**FEDERAL AVIATION ADMINISTRATION
AIRWORTHINESS DIRECTIVES**

BIWEEKLY 2000-02

Figure 1 of Docket No. 97-CE-67-AD
Compliance Table

FIGURE 1 to the Appendix

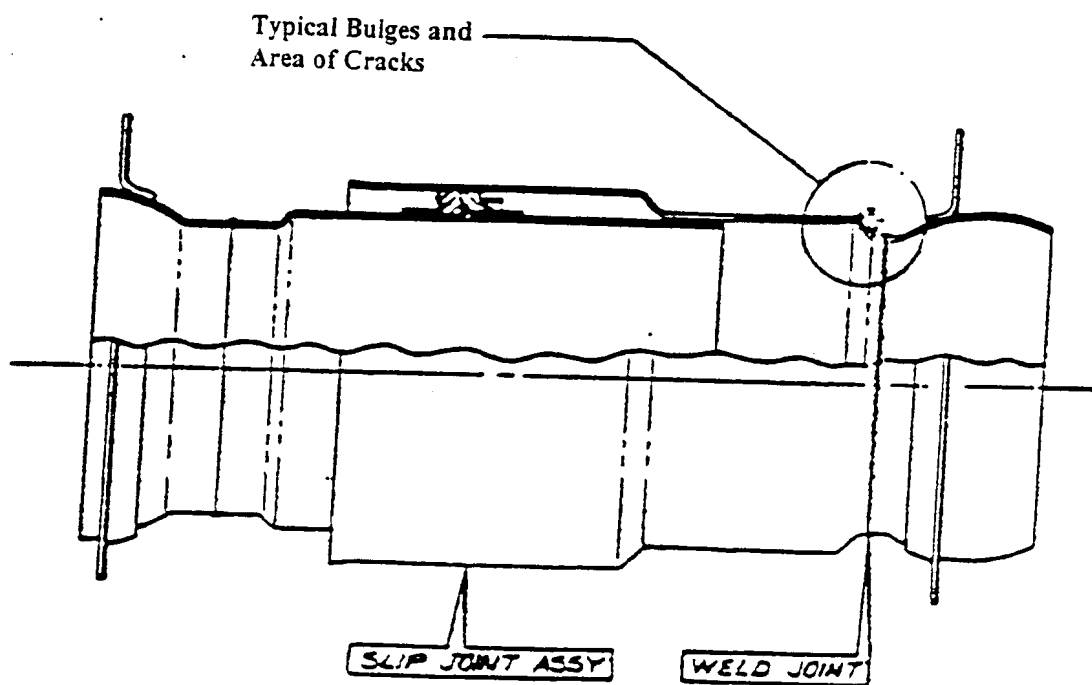
- (3) Visually inspect the exhaust joint springs for correct compression. If the joint is disturbed or if the springs are obviously loose or frozen, proceed with the following inspection (see Figure 1 of this Appendix).

- (i) Before removal of the exhaust joint springs, measure the installed length of each spring, and replace the springs compressed to less than .45 inch.

- (ii) Remove all the springs and measure the free length. Replace any spring having a free length of less than .57 inch.

NOTE 3: Add AN960-10 (or FAA-approved equivalent part number) washers under the head of the joint bolts as required to obtain the correct dimension. During installation, the joint bolts should be tightened gradually and spring length checked frequently to prevent over-compression of the springs.

FIGURE 2 to the Appendix

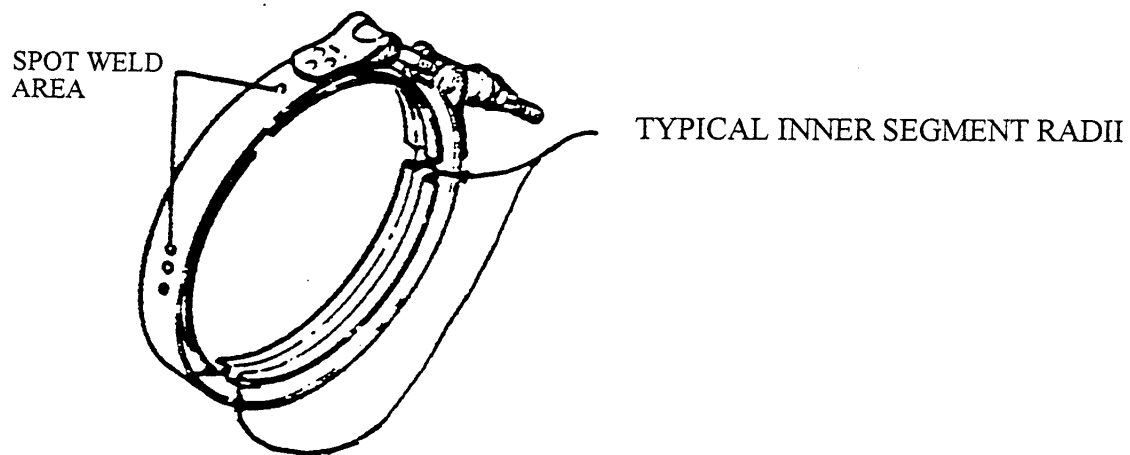
- (4) If installed, visually inspect the slip joint(s) for bulges beyond the normal manufacturing irregularities of .03 inches and/or cracks. If any bulges and/or cracks are present, replace the bulged or cracked slip joint(s). (Refer to the appropriate Cessna Aircraft Service Manual) (See Figure 2 of this Appendix).

FIGURE 3 to the Appendix

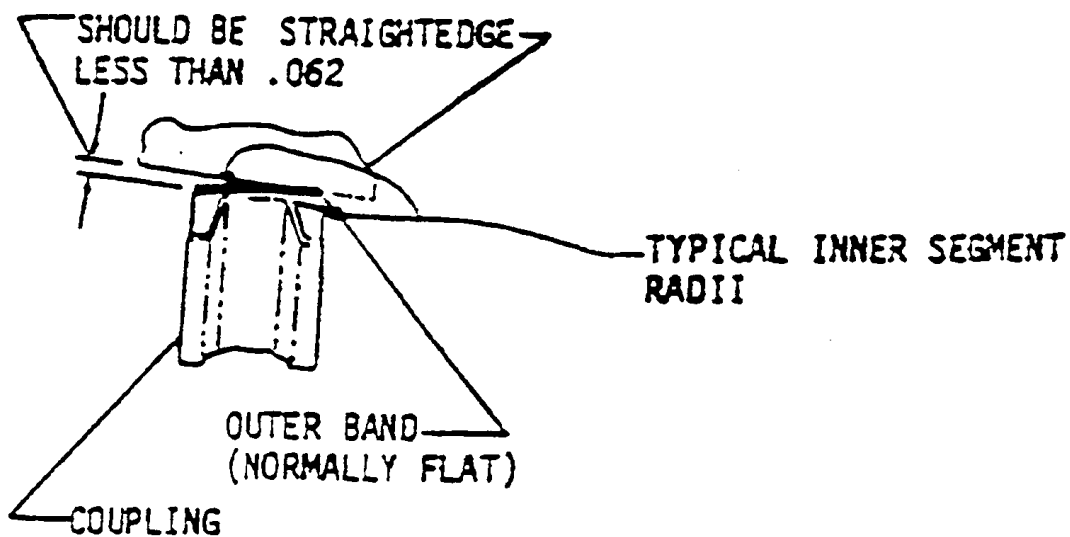
- (i) Visually inspect the outer band in the area of the spot weld for cracks (see Figure 3 of this Appendix). If cracks are found, replace the clamp(s) with new multi-segment "V" band clamp(s).

- (ii) Visually inspect the corner radii of the clamp inner segments for cracks (see Figure 3 of this Appendix). This inspection requires careful use of artificial light and inspection mirrors.

FIGURE 4 to the Appendix

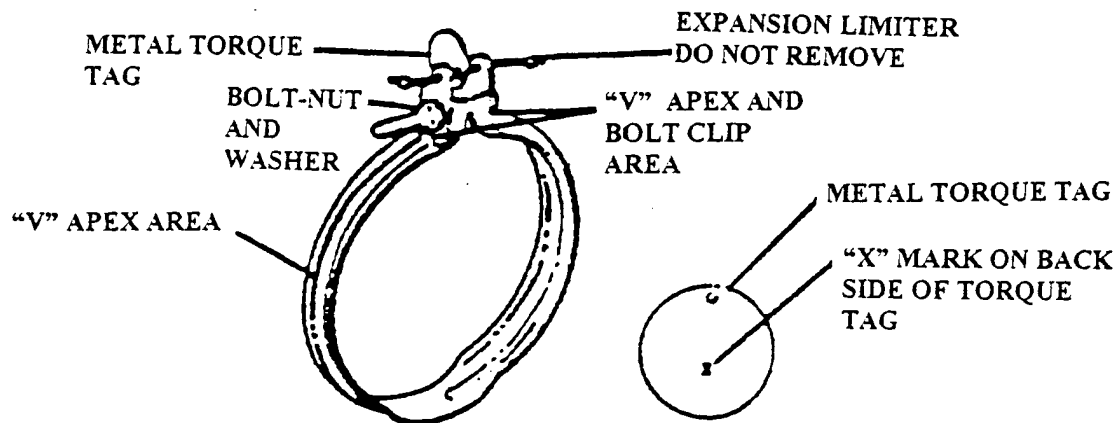
- (iii) Visually inspect the flatness of the outer band, especially within 2 inches of the spot welded tabs that retain the T-bolt fastener. This can be done by placing a straight edge across the flat part of the outer band as shown in Figure 4 of this Appendix, then check the gap between the straight edge and the outer band. This gap should be less than 0.062 inch. If deformation exceeds the 0.062- inch limit, replace the clamp(s) with new multi-segment clamp(s). (See Figure 3 of this Appendix). See Cessna maintenance manual(s) and revisions for correct installation procedures.
